RECEIPT DATE: 8/20/21      **ONSITE SEWAGE DISPOSAL SYSTEM**      P 570115  
 APPROVAL DATE: 11/2/21 (ST)      **PERMIT:**      **REPAIR**      A \_\_\_\_\_  
 PROPERTY ADDRESS: 1040 Fairlane Road  
 SUBDIVISION: \_\_\_\_\_ LOT: \_\_\_\_\_ TAX ID: \_\_\_\_\_  
 CONTRACTOR: Legacy Septic and Excavation      EMAIL: \_\_\_\_\_  
 CONTRACTOR ADDRESS: 1538 Manchester Road, Westminster, MD 21157      PHONE: 301-370-4121  
 PROPERTY OWNER: Neeraj and Nalini Harry      EMAIL: \_\_\_\_\_  
 OWNER ADDRESS: 1040 Fairlane Road, Woodbine, MD21797      PHONE: 631-745-4088

**MEMORANDUM**

**RE:** 1040 Fairlane Road  
Fairlane Farms, Lot 22

The OSDS Plan for 1040 Fairlane Road has been reviewed with the following comments:

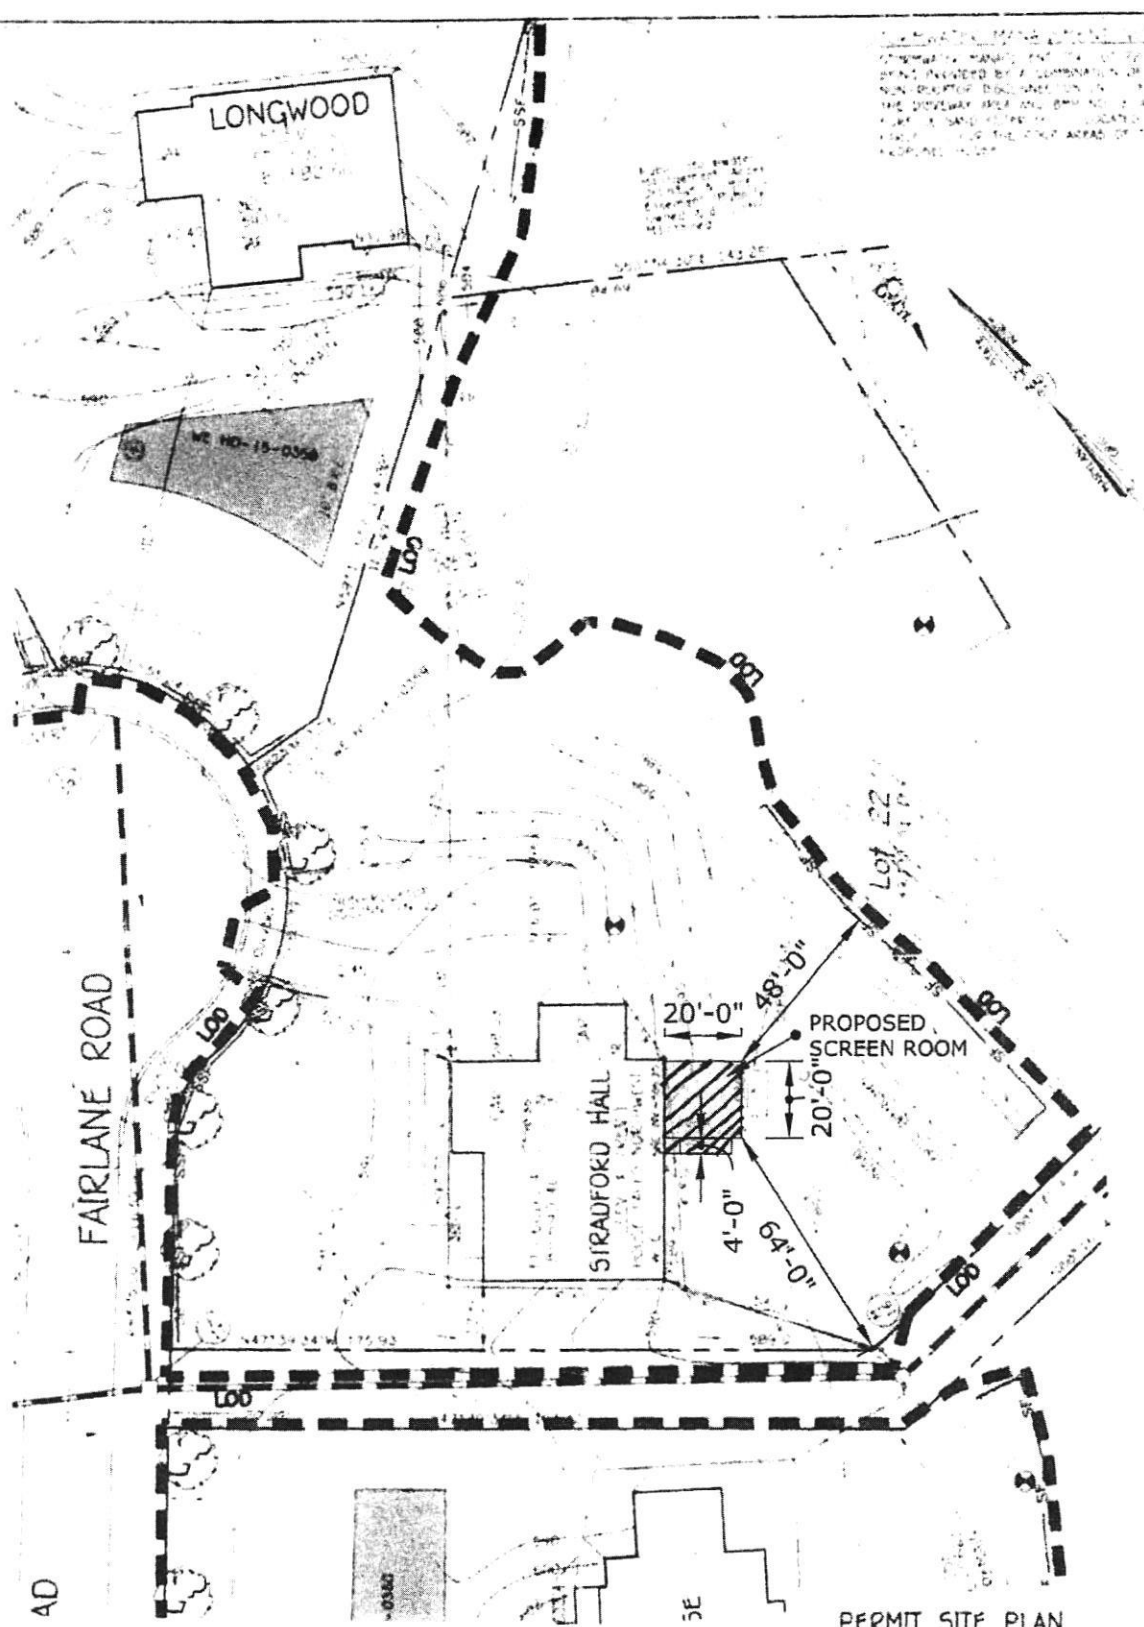
**I have reviewed your permit for your proposed addition is close to the septic tank and septic area. This distance is not within our required setbacks. Your septic system must be 20 feet away from your proposed addition. Please revise your plan and resubmit. If you need any additional assistance please don't hesitate to send me an e-mail regarding setback requirements.**

Attached, you will find a diagram of the proposed deck.

PERMIT SITE PLAN  
 LOT 22  
 1045 FAIRLANE ROAD  
 FAIRLANE FARMS

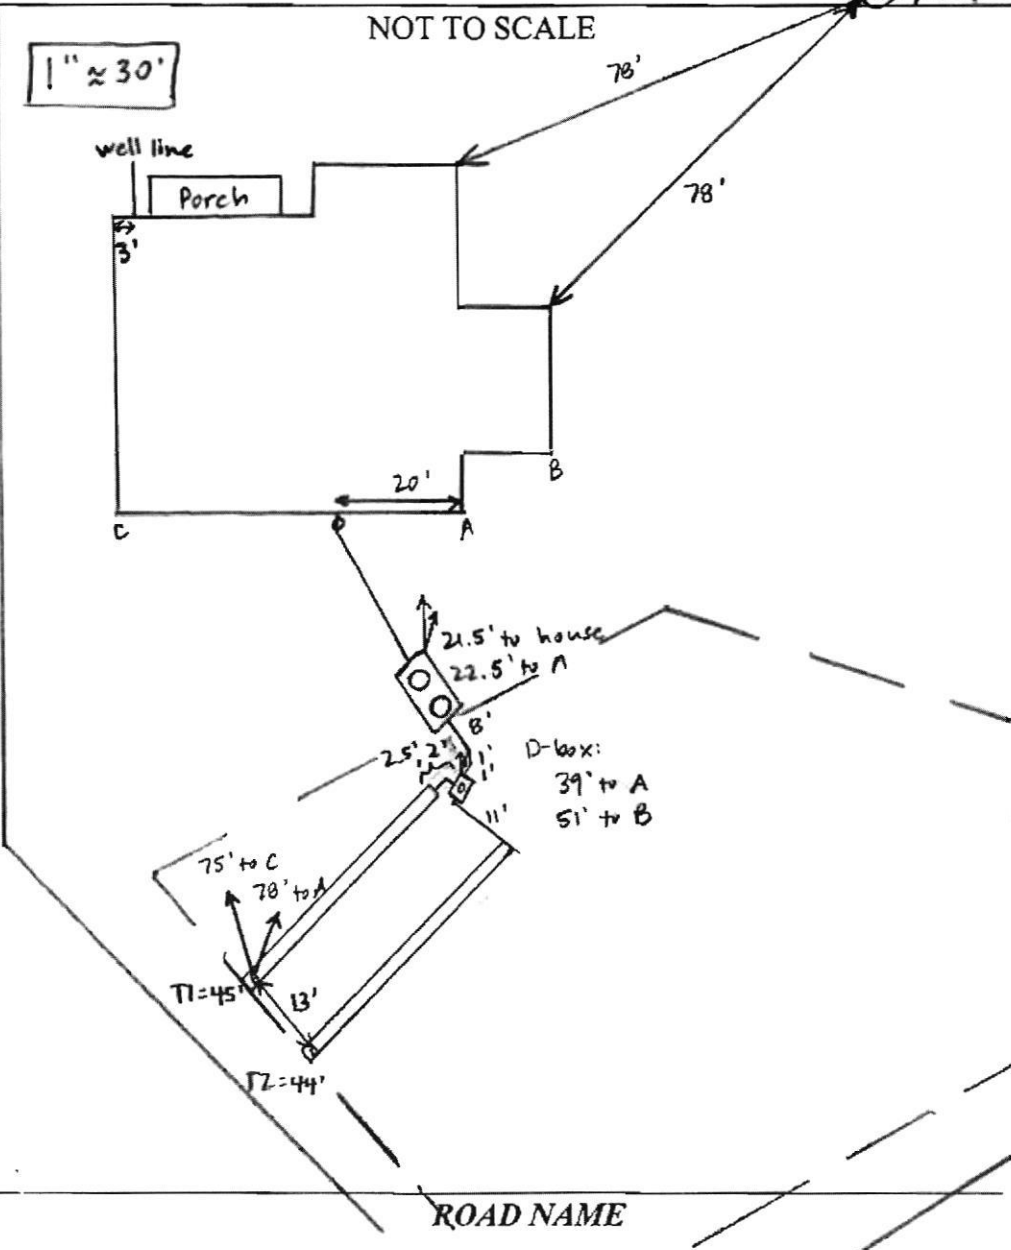
- 1.) For 5 foot of side wall credit, raise invert up to 3 feet, and change trench data plus trench detail to reflect.
- 2.) Change trench layout for 1<sup>st</sup> and 2<sup>nd</sup> replacement to reflect proper lengths on plan

Here are 3 new copies of the OSDS for Lot 22 with comments addressed, and ready for your approval. Please let me know if you have any questions.

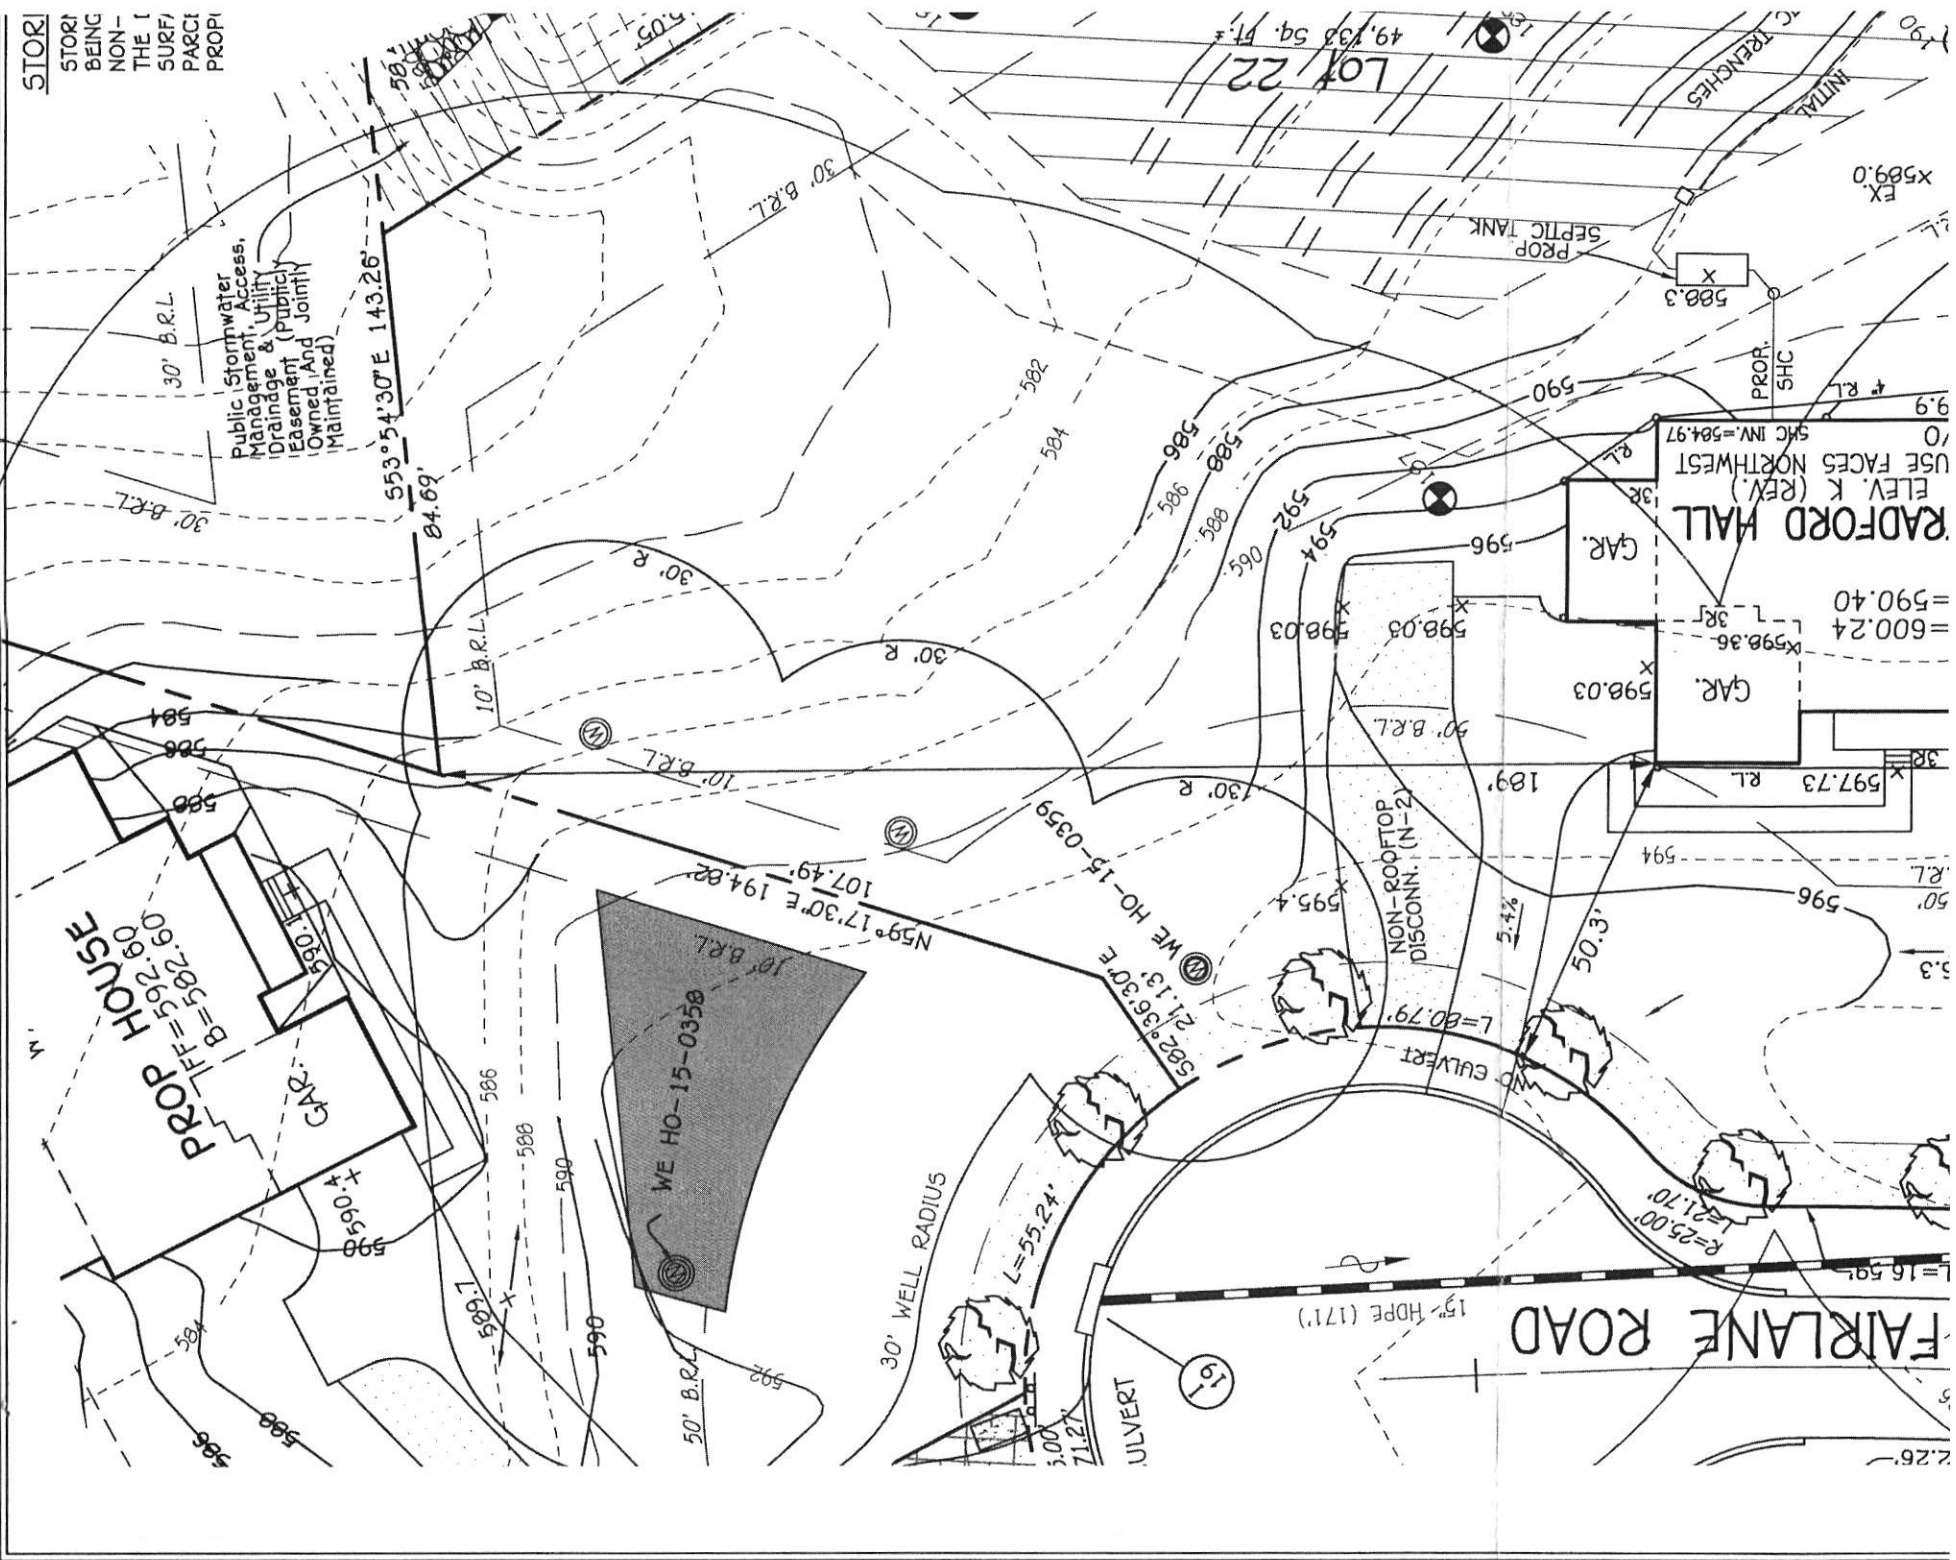
For the future storm water management pond next to Lot 22, we would like to see the 25 foot setback from the 580 line because that's where the outflow is located (See attachment). As a reminder, if you have to revise the SDA, then a revised perc cert will be required.
